932 PITTWATER ROAD DEE WHY

DEE WHY RSL CLUB

Design Statement

The following design statement seeks to outline some alterations to the approved DA2017/0244 of Dee Why RSL Club at 932 Pittwater Road, Dee Why. The initial DA comprised of the partial demolition of the existing southern car park and replacing it with a new car park which is both underground and above ground with an expansion of the clubs main trading floor. The proposed building would activate the street with a suitably scaled building with extensive landscaped buffer/streetscape and provide a major and enhancement to what exists today. While we intend on making some alterations to the approved DA, the overall scope of the works and philosophy of activating the street has not changed from the original DA. The most significant alterations are as follows:

Figure 1a. Revised design: plant room under under 12m height plane

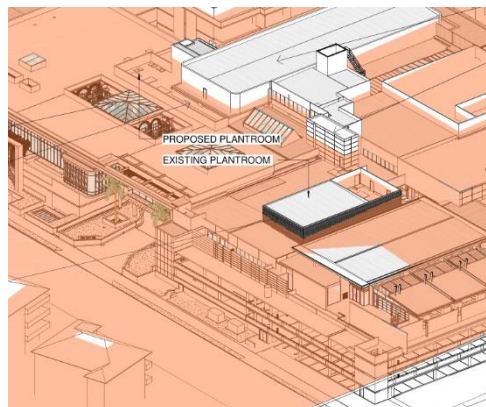
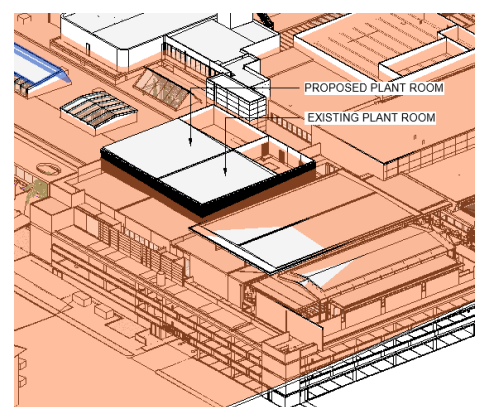
The relocation and reduction in size of the plant room has resulted in plantroom now complying with the 12m height plane as outlined in the DCP.

Figure 2a. Revised design: all skylights under 12m height plane

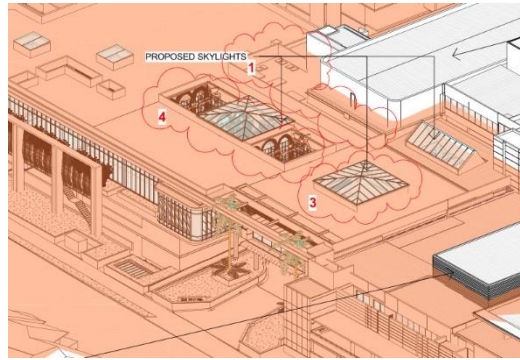
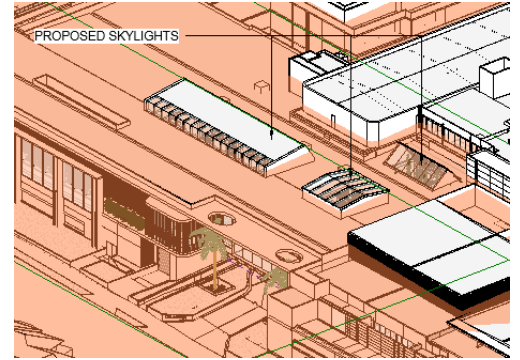
The new layout of the courtyards and skylights above has been included to provide a more human scale in this part of the main trading floor as well as providing an alfresco non-smoking area for this part of the club. The new layout provides three separate courtyard areas, two external and one internal within the main food and beverage precinct. This is an important aspect of design as the main space achieves a certain degree of variety and becomes more clearly identifiable. All roof skylights are under the 12m height plane

Figure 4a. Extent of Level 2 reduced

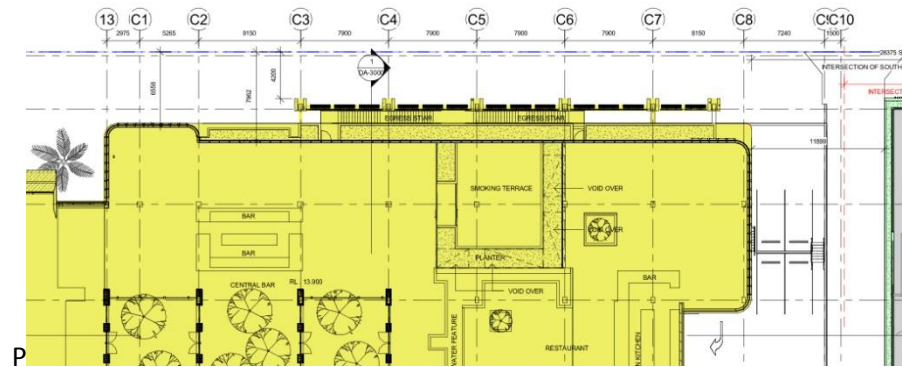
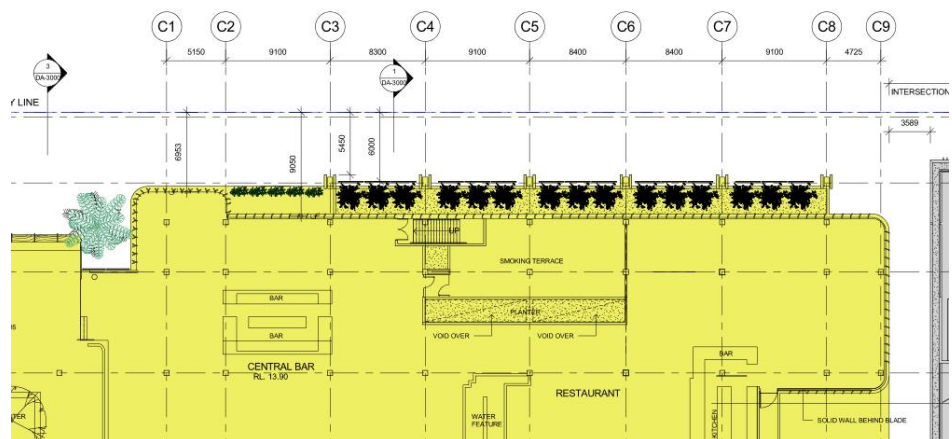
While the footprint of the main trading floor has been reduced from the southern boundary and increased to the eastern boundary, the language of the streetscape has not been affected as all the same façade elements from the approved DA have either been kept or enhanced as described below.

Figure 5a. Revised design: extent of screens indicated with blue dashed line

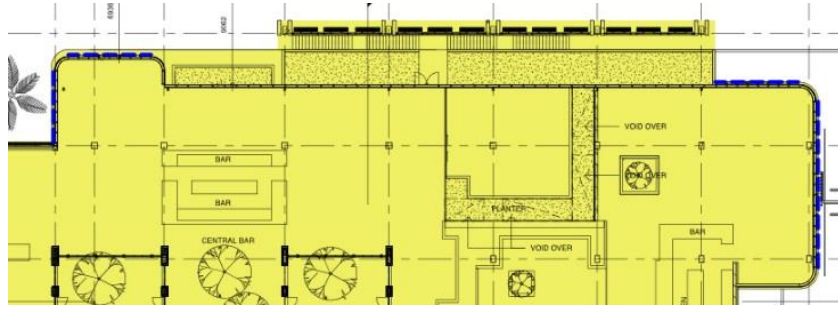
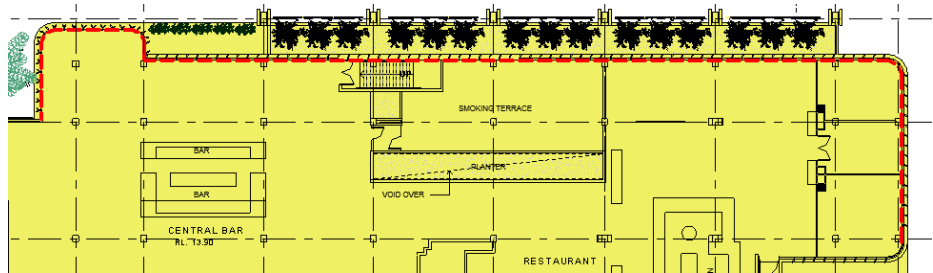
The mullion blades have been developed into a screen that creates a link between vertical mullions. The screens are intended to soften the overall impact of the façade as well as to accentuate specific areas described as urban activators in the DA design statement: the entrance and the southern corner.

Figure 9. Median strip to vehicular entrance

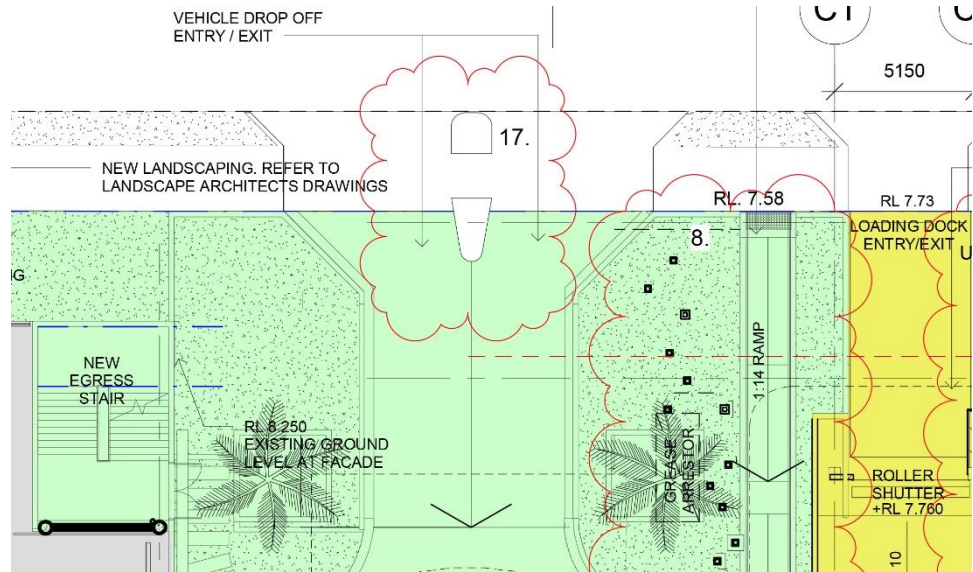
DA condition 23 states that a maximum entrance width of 8m is permissible at the main entrance of the club. To achieve this, a new median strip is proposed at the main vehicle entrance on the site. A refuge space of 1.5m between the entry and exit aisles which are both 5.73 m wide which is below the permissible

8 m.

Figure 3a. Reduced basement car park levels

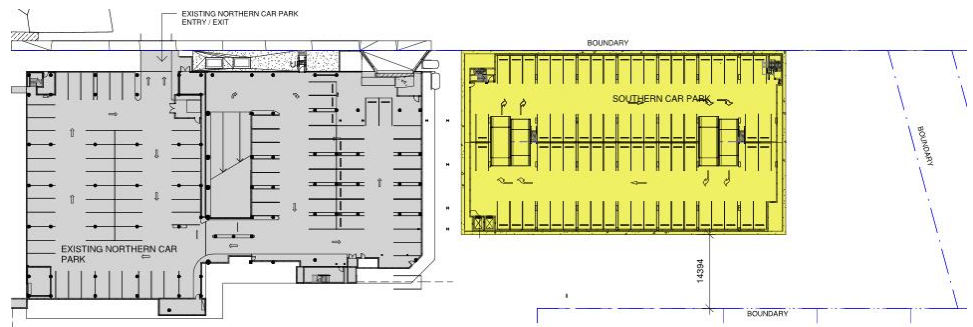
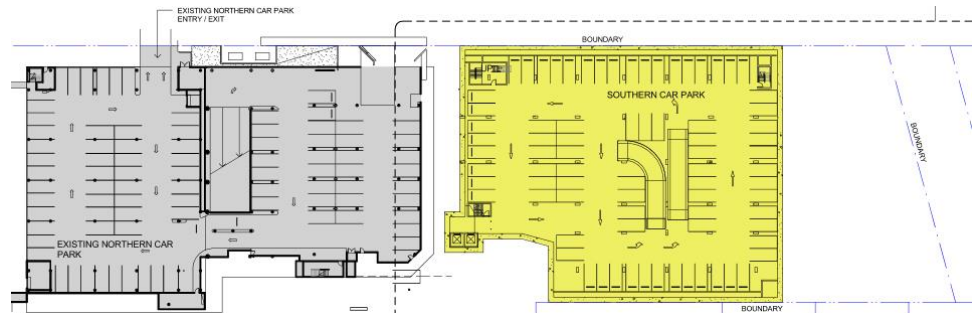
Basement reduced by 14394mm from the west boundary. Carpark changed from flat plate to split level on all levels. Depth of car park increased from RL -3.600 to RL -5.700. Overall parking spaces on the site has been reduced from xx to xx
